Generation
II™

SONCELL NORTH AMERICA
A PUBLIC SAFETY COMPANY

REV. 1-3-23

SUPPLEMENTAL INSTRUCTION SHEET FOR RETROFITTING NEWER GEN II MODULES INTO EXISTING INSTALLATIONS

OLDER MODULE IDENTIFYING ATTENUATOR LOCATION & CONNECTOR

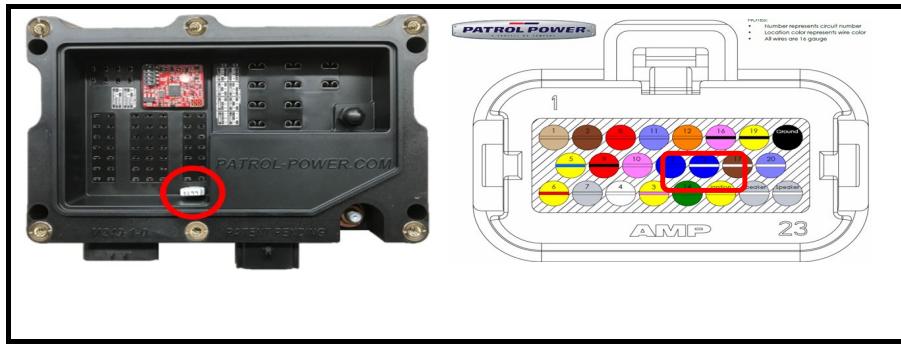
We have ceased production GEN II fuse blocks that featured the siren attenuator. The new fuse block has been designed to be backwards compatible with existing installations with the exception of the aforementioned attenuator circuit.

Older fuse panels with the attenuator circuit are clearly identifiable by the attenuator position in the lower, center fuse portion of the fuse block and by the presence of two GRY/WHT wires in the harness (pins 22 & 23 of the 23 pin connector). The wire harness will need to be modified, but only if the siren attenuator loop is being utilized in the vehicle. If the siren attenuator loop is not being utilized, no further modifications will be necessary. If you aren't sure if the siren attenuator is being used, there are a few ways to determine this.

- 1) Is there a fuse or a resistor in the siren attenuator location in the fuse block? If there's a diode or nothing, the attenuator loop isn't being used.
- 2) If the attenuator location has a fuse in it, remove the fuse. If the siren speaker still functions, the attenuator loop isn't being used. If it stops functioning, the attenuator loop is being used and you will need to connect the two GRY/WHT wires to each other on the harness side, not the fuse block side. Refer to diagram to right.
